## QUALITY ASSURANCE -- NON-CONFORMANCE REPORT

**Report No:** NCR-000887

**Reference Description:** Heat Straightening without Engineer's Authorization

**Job Name:** SAS Superstructure

Reference attached pics.

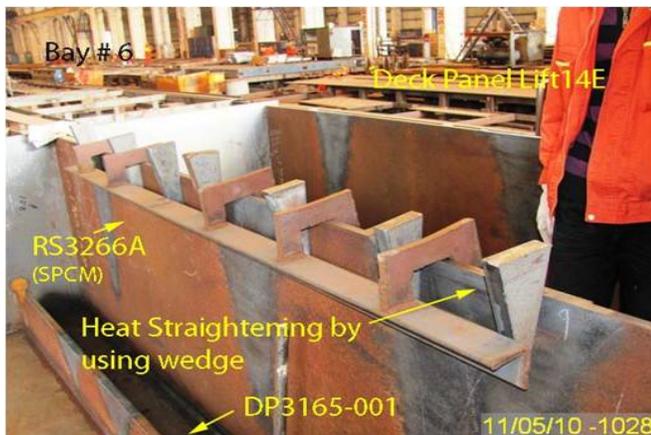
During the Quality Assurance (QA) random in-process visual inspection of Orthotropic Box Girder (OBG) lift 14E Deck Panel, this QA inspector discovered the following issues:

- ZPMC personnel performed Heat Straightening of Lift 14E Deck Panel, utilizing HSR-1-9707.
- ZPMC deviated from the standard HSR-1 repair, by mounting a temporary fixture and driving unidentified steel wedges between the fixture and SPCM material.
- The SPCM steel plate is identified as RS3266A.
- The affected Deck Panel is identified as DP3165-001.
- The material is A709 Grade 345 Seismic Performance Critical Member (SPCM).
- OBG Deck Panel is located in the Bay 6.

AWS D1.5/2002 Section 3.7.3: "Members distorted by welding shall be heat straightened by mechanical means or by carefully supervised application of a limited amount of localized heat as approved by the engineer". Also "jacks shall be used in such a manner that all forces are applied passively."

This NCR was not justified when issued. No mechanical means or jacks were used during the application of heat. The notes at the bottom of the HSR-1 referenced the additional measured used by ZPMC during heat straightening. A ZPMC QA Engineer arrived and explained this to the Department's representative at the time the issue occurred. Based on this NCR should be closed.

The proposed resolution is acceptable. This NCR is closed.

Contractor has not accepted the NCR. The issue has been clarified to the QA Engineer on the spot and also the Department's representative and the explanation has been accepted.
